## Section 75W Modification

MP08\_0222

### Global Switch Sydney Switch East Data Centre

May 2013

**Approved Cross Section – 1 basement and 6 Storeys (including mezzanines) above**

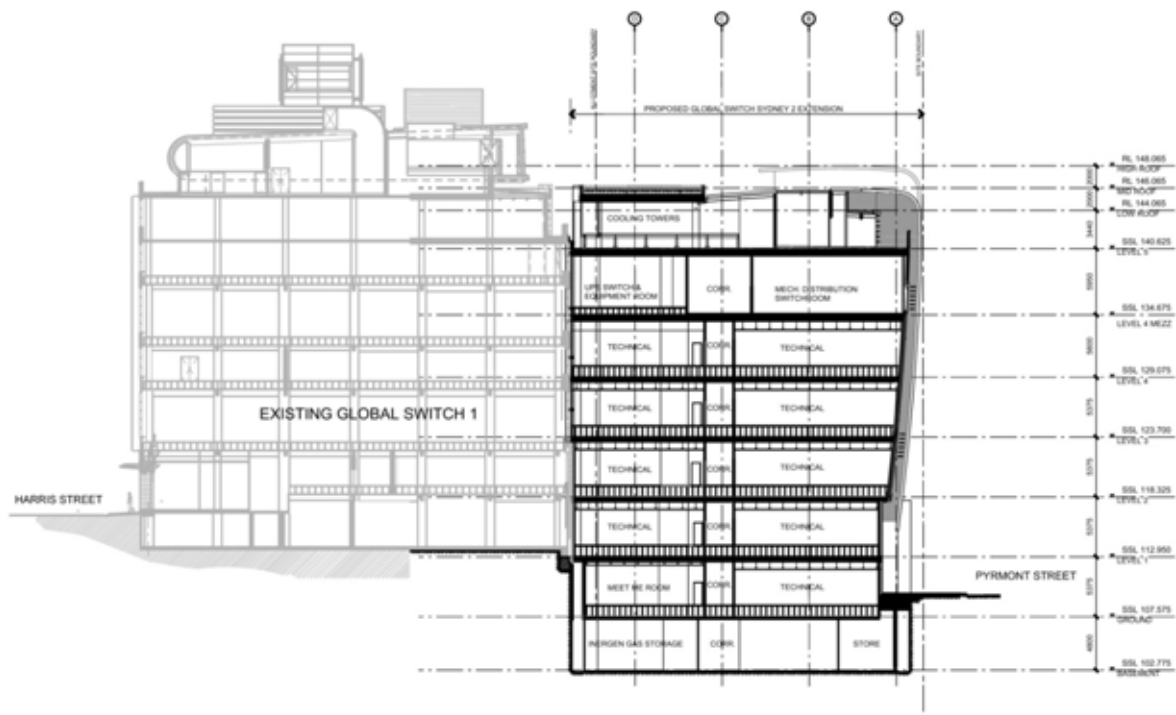
**Modified Cross Section – 1 basement and 6 Storeys (including mezzanines) above**

The approved building footprint, height and external appearance **remains unchanged**. The only minor external changes proposed relate to the roof level plant area which has some plant equipment reorganised to facilitate better services reticulation and maintenance and the configuration of the Green Roof which has been rationalised to facilitate staging and services reticulation.
